Groundwater Application Review Summary Form

Application # G- 19356

GW Reviewer Phillip I. Marcy Date Review Completed: 05/04/2023

PUBLIC INTEREST REVIEW FOR GROUNDWATER APPLICATIONS

Cross-Section

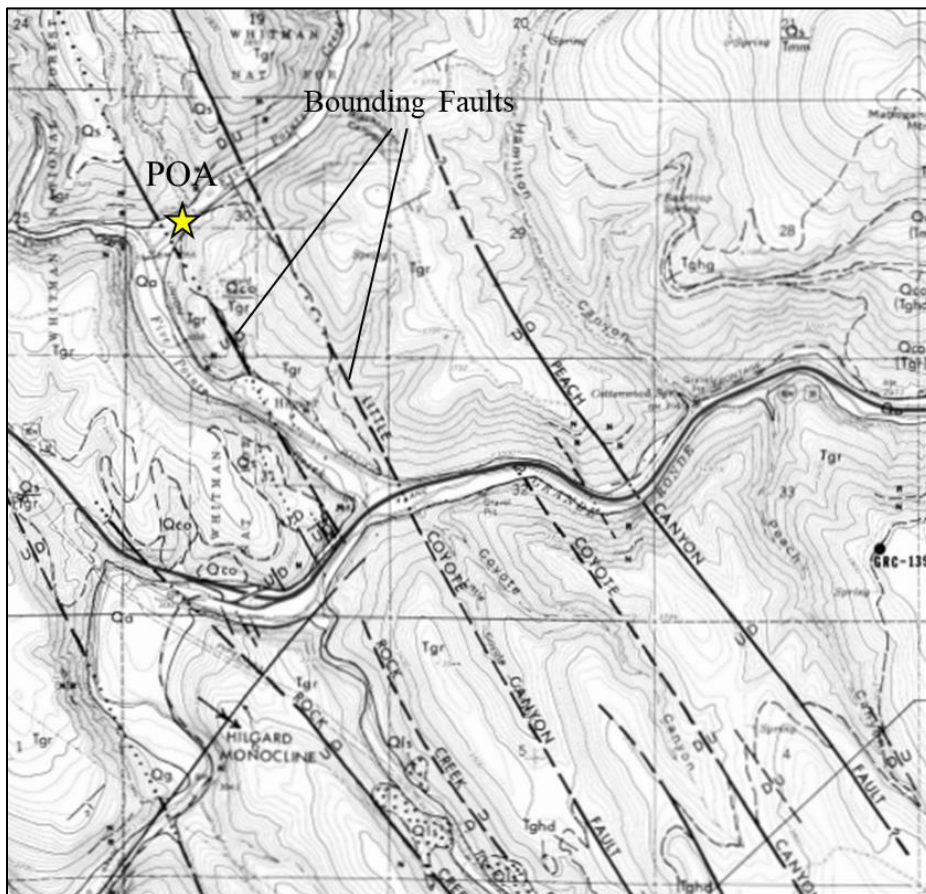
A cross-section from N (left) to S (right) with prospective fault geometry and resultant bedding drawn in. In this conceptual model, the applicant's proposed POA is located on the down dipping end of the fault block. This model also treats the fault zone as a barrier to groundwater movement, rather than a conduit for flow.

Geologic mapping indicates the proposed POA is contained within a narrow, down dropped graben block of Grande Ronde Basalt. This structural framework is anticipated to provide some degree of hydraulic isolation from surrounding water-bearing zones and surface water features. Modified from Barrash and others, 1980.
